Addison Airport Customs and Border Protection Facility Change Order No. 3

Staff Presentation

October 13, 2020

Dry Wall Adjustment for Plumbing

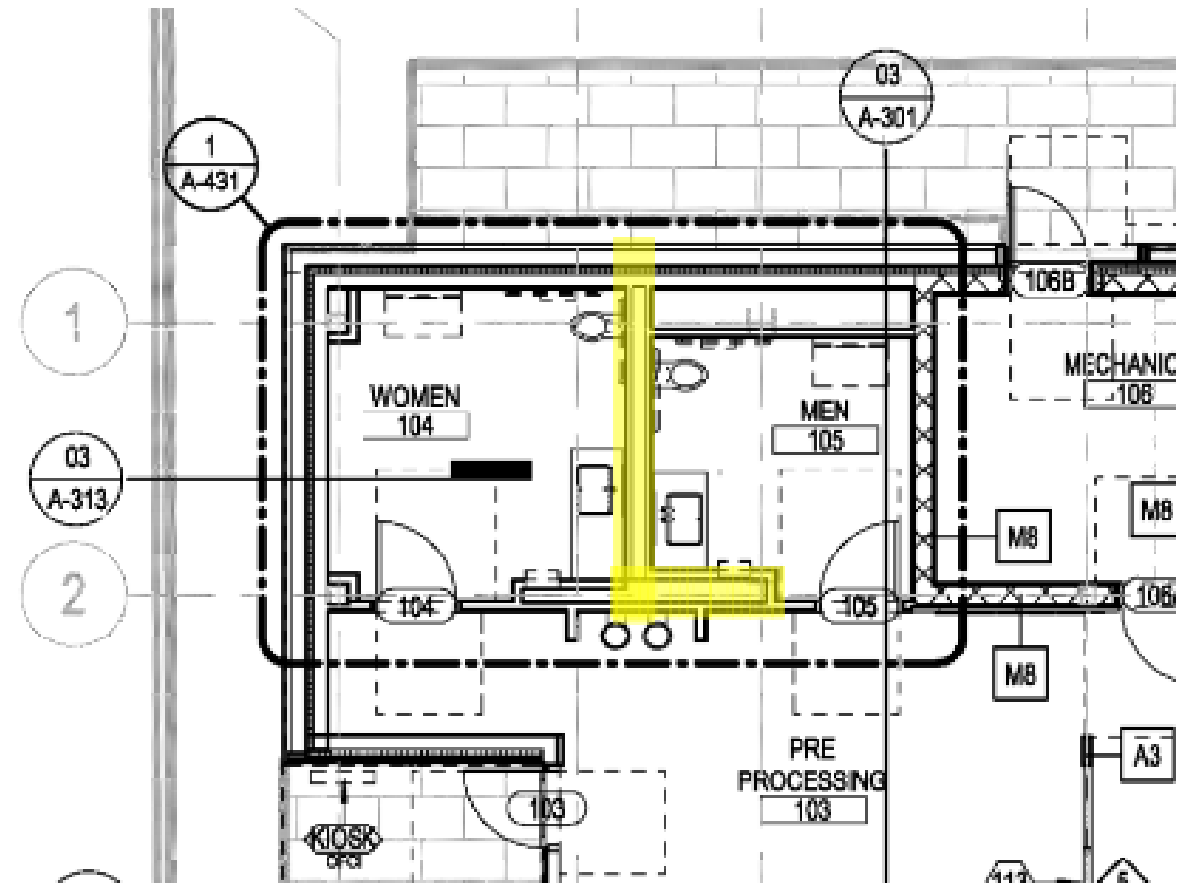
- First floor wet wall plumbing chase between 'Women 104' and 'Men 105'
 - Plumbing chase depth was too narrow to accommodate the back to back toilet carriers and any plumbing crossovers
- The contractor was directed to expand the width of this chase and modify its extents to provide adequate covering of toilet plumbing.

Landscaping and Irrigation Changes

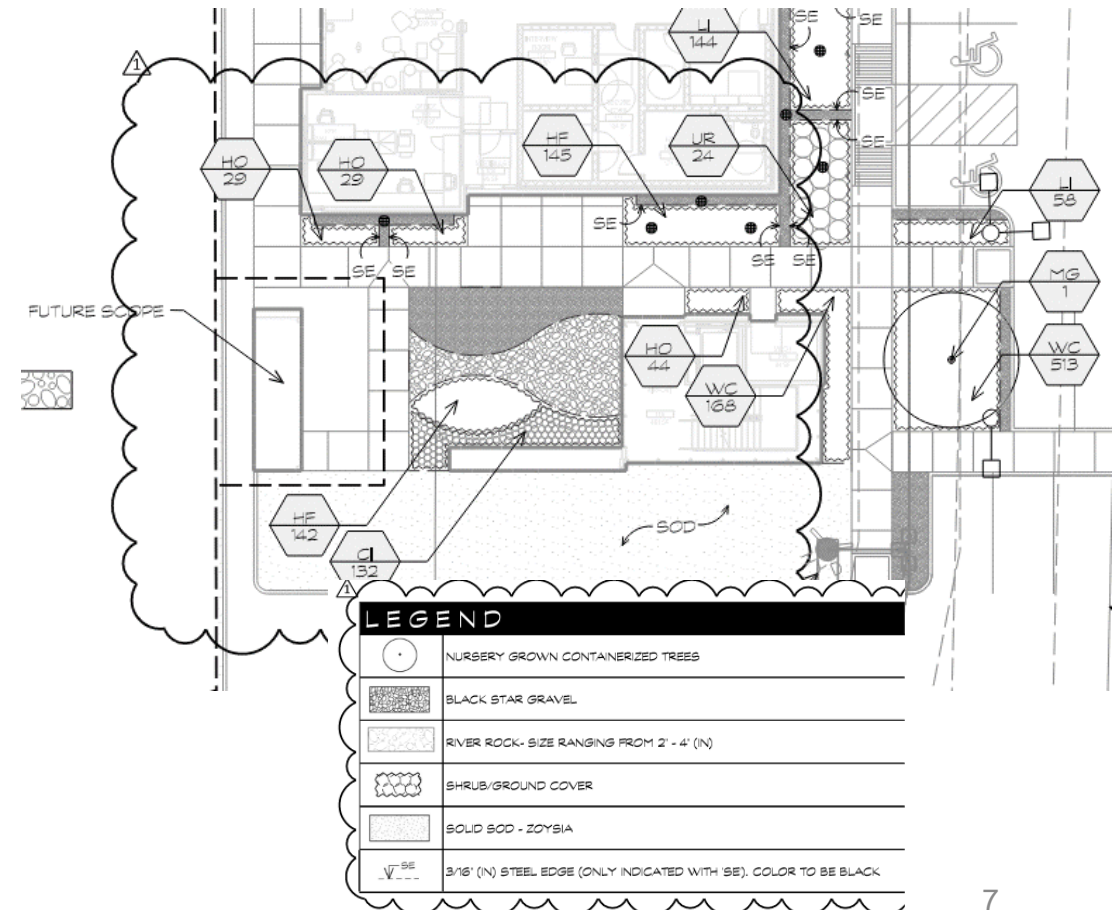
- Revisions were made to the landscape plans and planting designs to include more shade tolerant plants and a more suitable aggregate design for under the buildings shaded breezeway.
- Irrigation designs were updated to match the revisions to the plantings and aggregate design changes.
- The revised plants and aggregate designs were reviewed on-site with the Town Arborist to ensure these changes are in compliance with the Town of Addison standards.

Exterior Elevations from sheet A-201 after the revisions (Current):

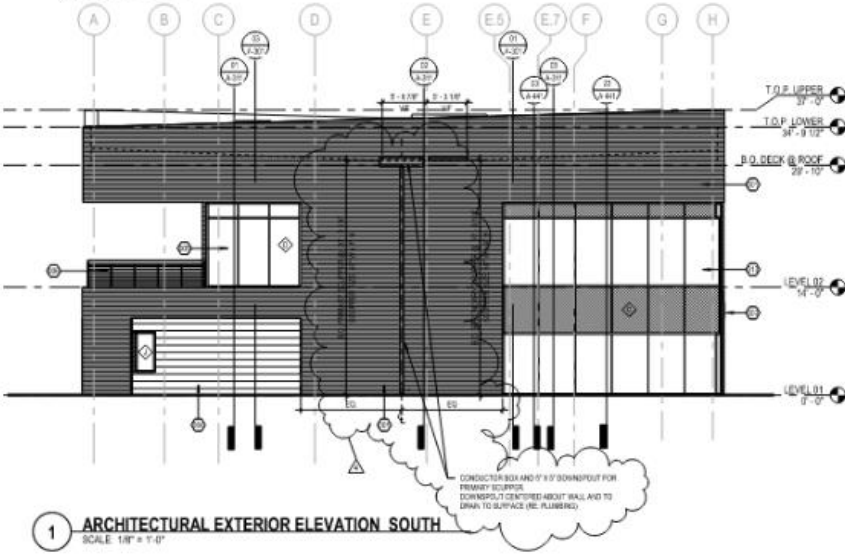
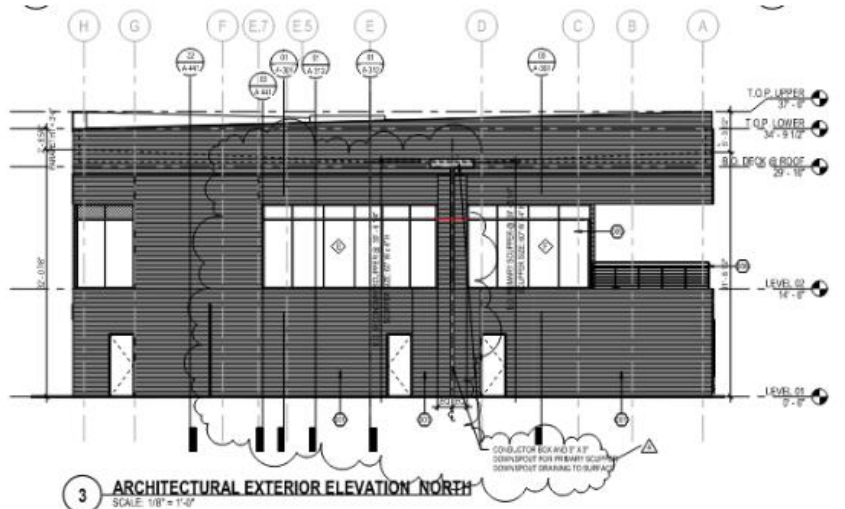
- Scupper and Downspout calculations were revised based on the comments received from the Town of Addison Building Permit reviewer.
 - Made scupper openings in the parapet wall larger
 - Add a secondary emergency overflow opening
 - The recessed and hidden downspout was shifted for the primary drain to be exposed on the exterior of the building for the ease of any future maintenance.

Drywall Support Labor

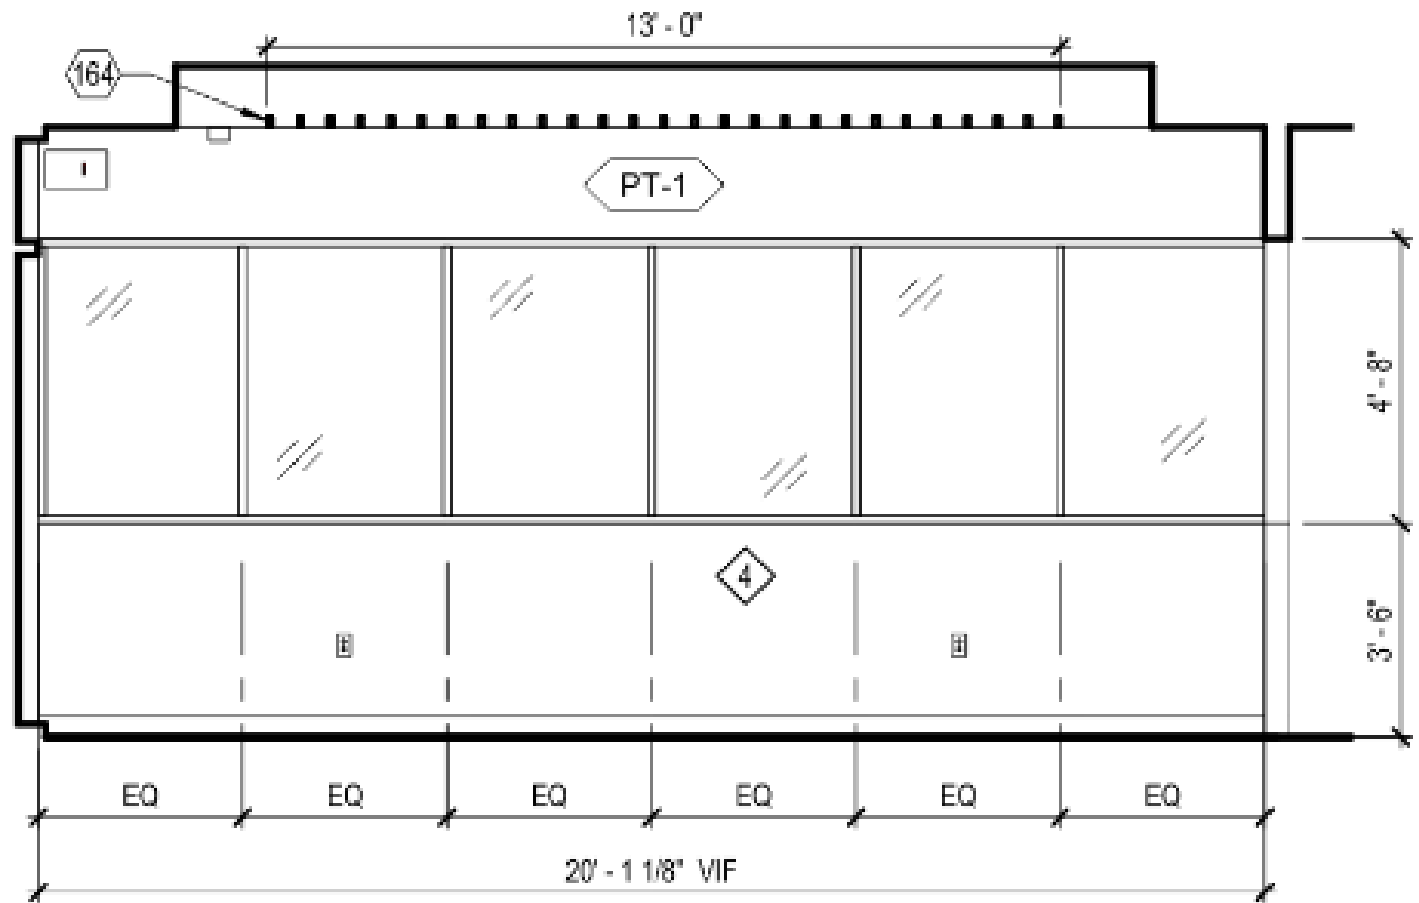
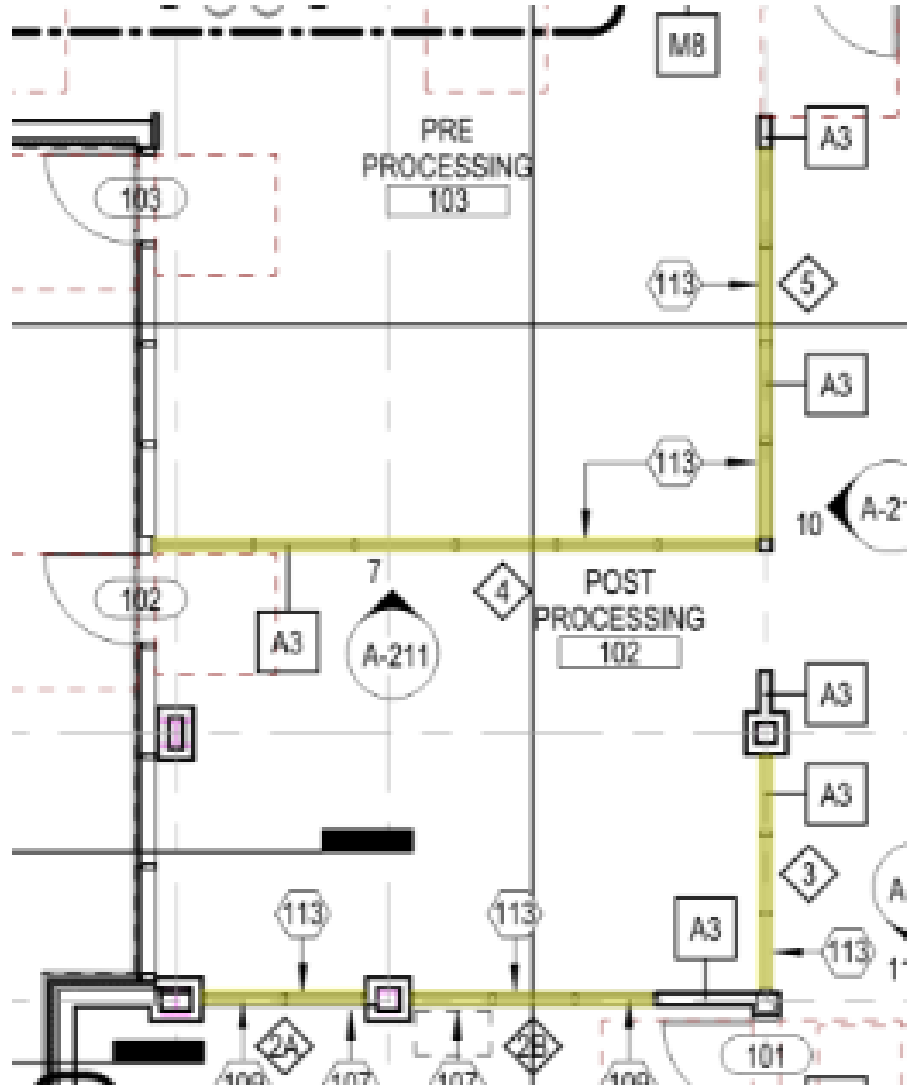
- Drywall framing installed for the walls between the 'Pre Processing 103' and 'Post Processing 102' rooms have glass and aluminum framing that take up the top half of the wall which does not allow the stud framing to run continuously from floor to deck above.
- The wall support elements were installed below the windows inside the 3'-6" tall section of drywall framing to brace the wall from overturning/folding if a lateral force is applied to it in the middle of the wall.

From electrical drawing - ES -102. items to be removed from the scope of work as mentioned in the list above.

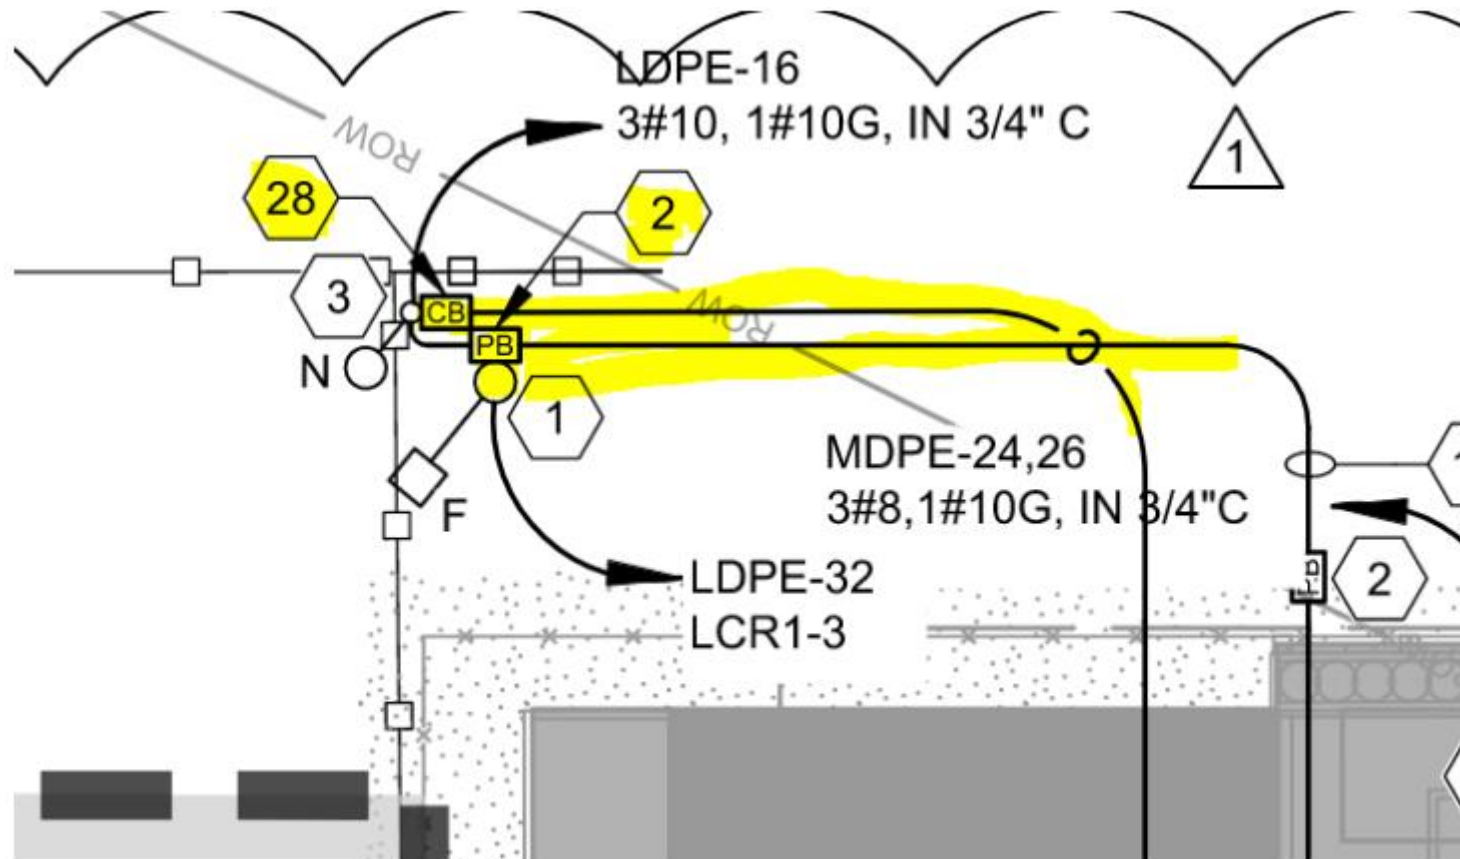
- The proposed Northwest security camera pole is in a location that will conflict with the airside construction.
- The Northwest light and camera pole concrete foundation and erection of the pole will be removed from this contract as a credit.
- The airside project will perform the installation of this light and camera pole with foundation as well as extend the conduit to this proposed pole location.
- JC Commercial will provide the light pole to the airside contractor and will still be responsible for the installation of the wiring, fixtures, and cameras upon completion of the light pole foundation performed by the airside contractor.

Additional Hardware for Door

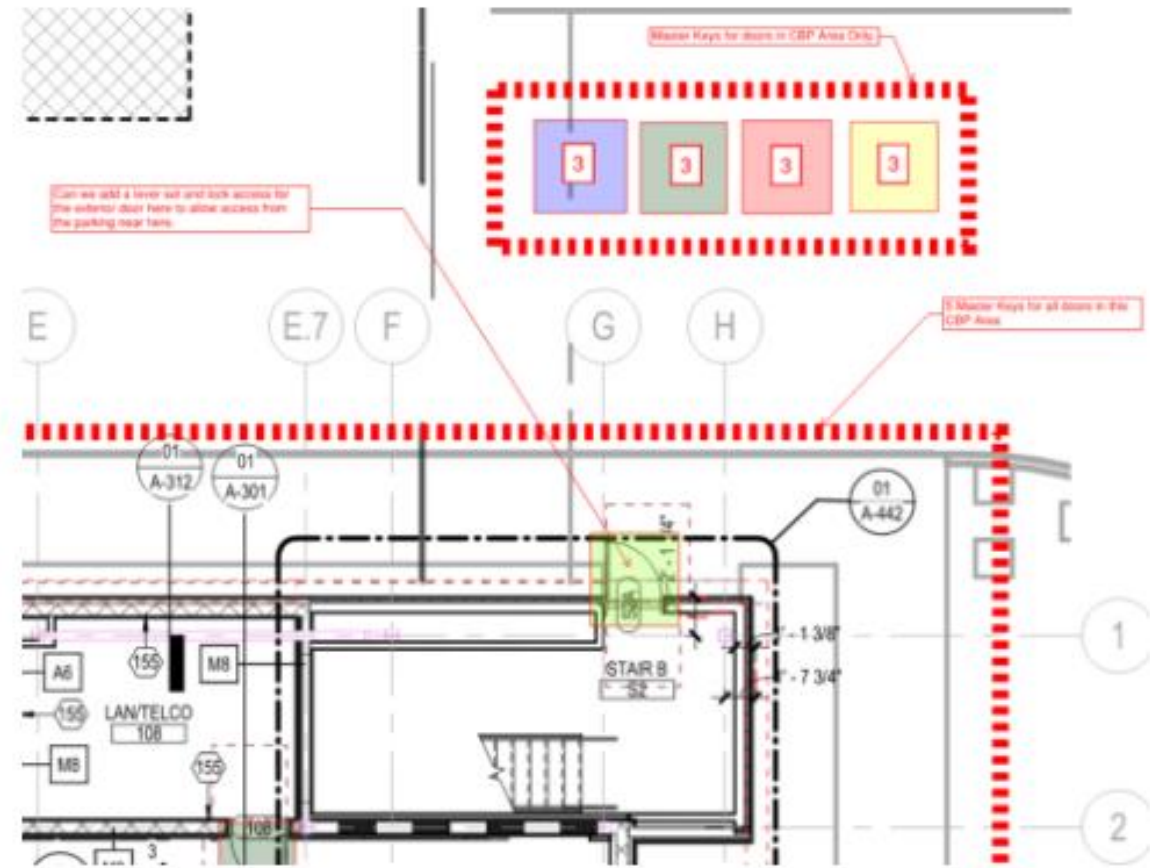
- Airport Staff requested to have access to the building using the exterior stairwell door at the northeast corner of the building for operational purposes.
- Additional hardware ordered for Door S2A for keying and access paths into and out of the building to generate the keying schedule.

11 ELEVATION @ WOMEN'S RR 215 - EAST
SCALE: 1/4" = 1'-0"

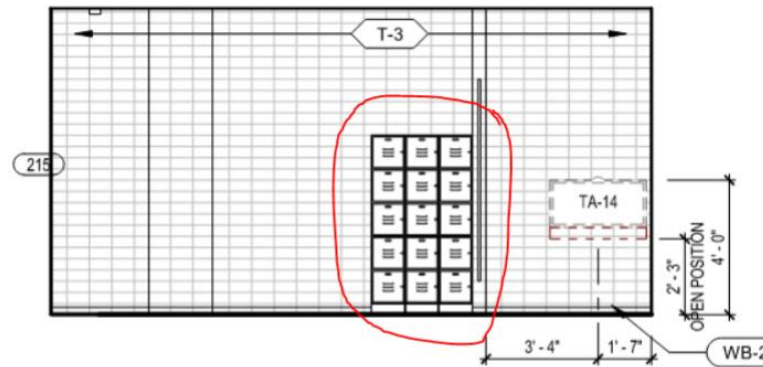
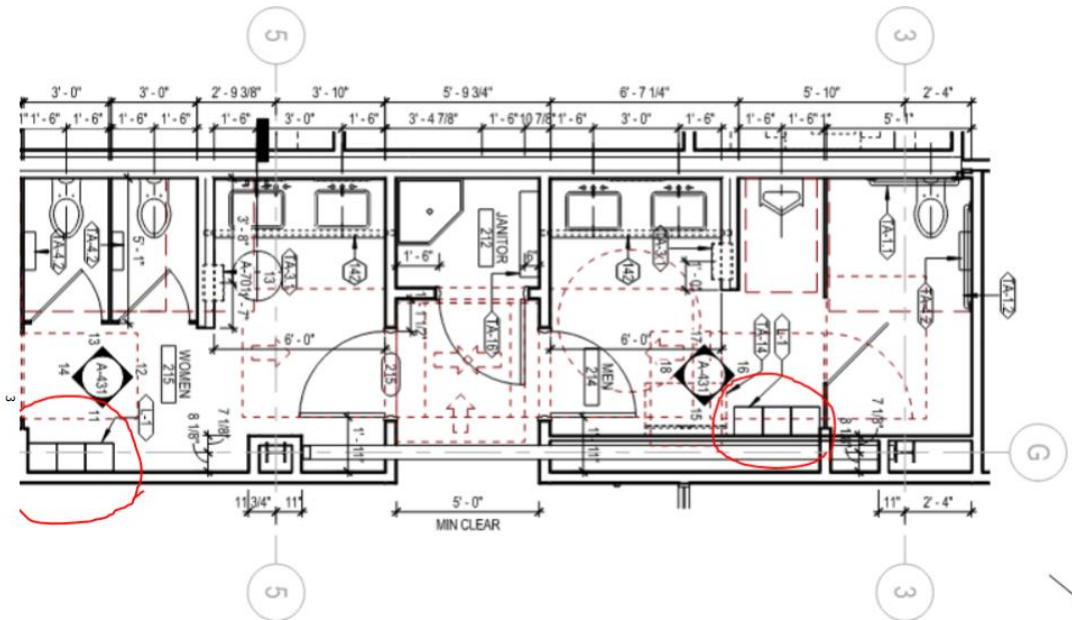
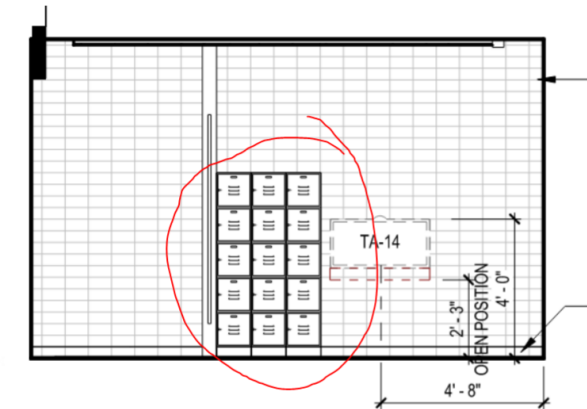
- Lockers Credit to remove the small metal lockers from the project scope in the gang restrooms on the second floor.
